Service Bulletin

Bulletin No.: PI1199

Subject: Engine Cranks But Does Not Start, Engine Cranks With Loud Backfire, Engine Will Start and Stall

Models: 2014 Chevrolet Silverado 1500
2014 GMC Sierra 1500
Equipped with 4.3L V-6 Engine — RPO LV3
Equipped with 5.3L V-8 Engine — RPO L83

3709109

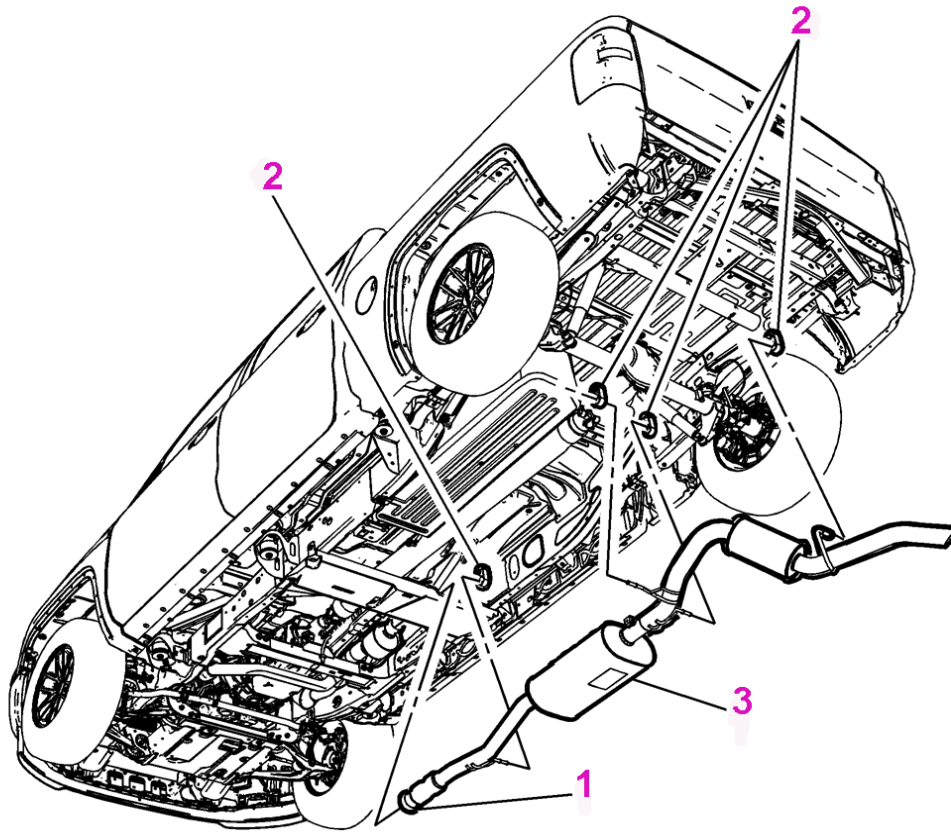
The Condition/Concern may be caused by ice buildup in the exhaust system causing the passive exhaust valve (PEV) to stick in the closed position.

3. Exhaust system part identification:
- Exhaust Muffler Clamp Fastener (1)
 - Exhaust Muffler Isolators (2)
 - Exhaust Muffler (3)

4. Replace the exhaust system. Refer to: Exhaust Muffler with Resonator, Exhaust, and Tail Pipe Replacement in SI.
